**PROPOSED CHANGES TO OPERATING LICENSE,
TECHNICAL SPECIFICATIONS
AND BASES**

NIAGARA MOHAWK POWER CORPORATION

LICENSE NO. NPF-69

Proposed Changes to the Operating License, the Technical Specifications and the Bases Section of the Technical Specifications

FIGURE 3.4.1.1-1 PERCENT OF RATED CORE THERMAL POWER VS. PERCENT OF RATED CORE FLOW

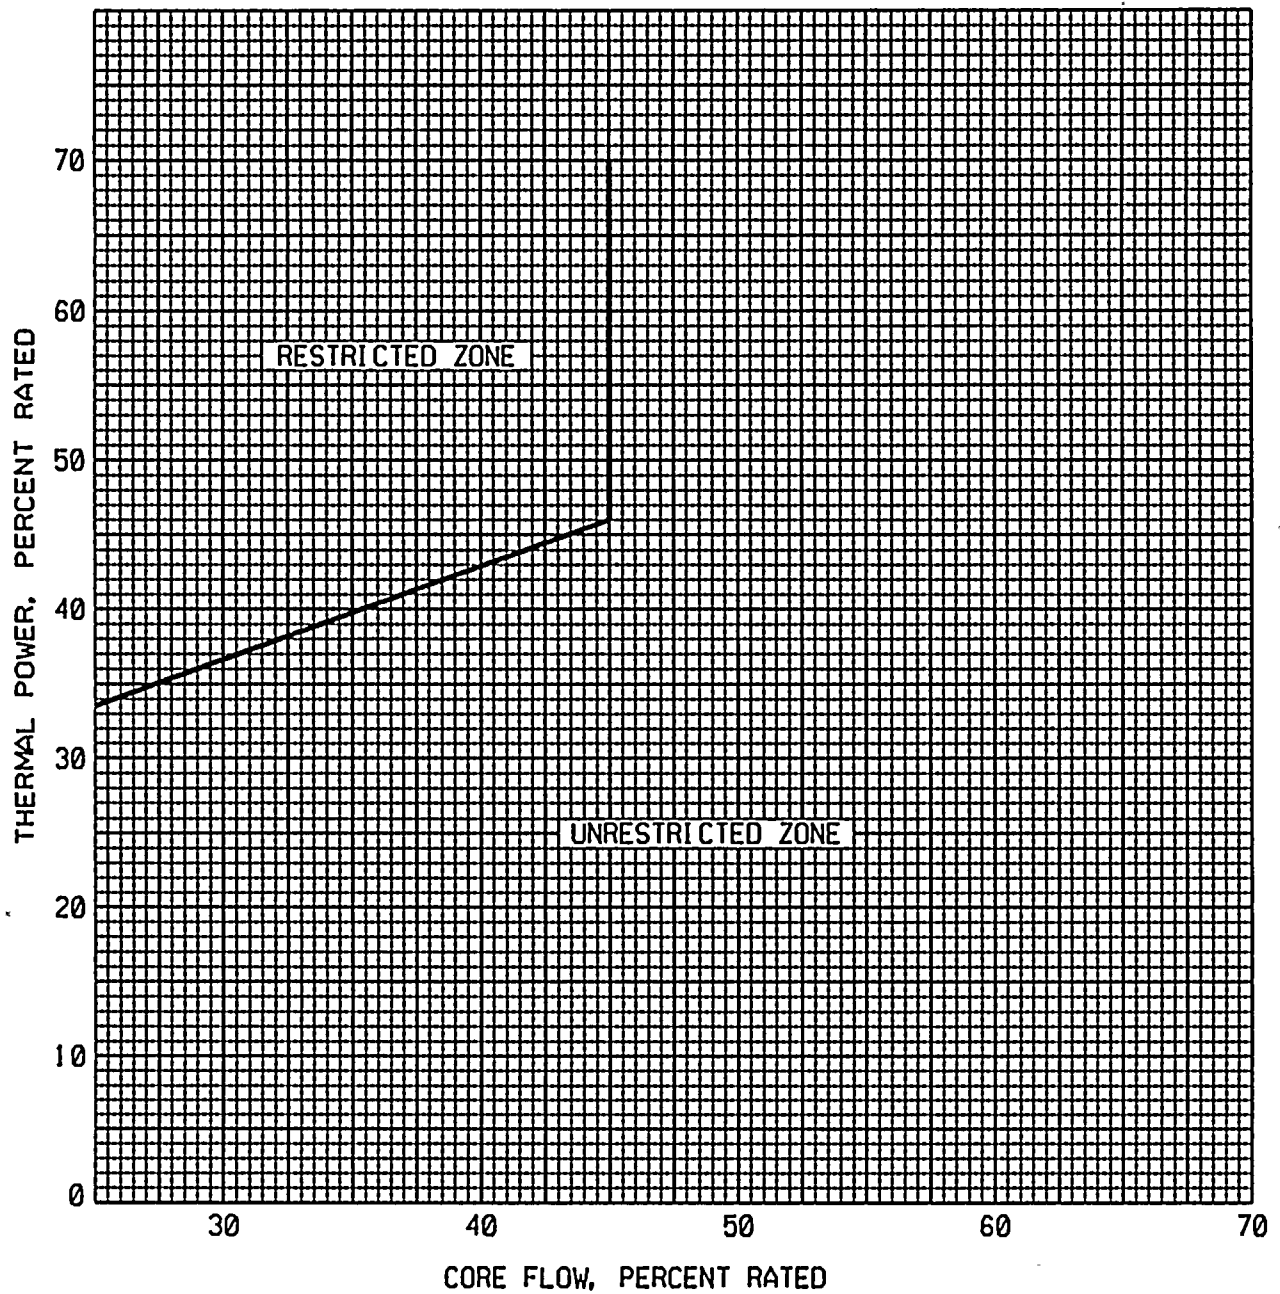
Replace each of the pages, as identified below, with the corresponding revised page. Each revised page is a one for one replacement of the current page. The proposed revisions are indicated by markings in the margin.
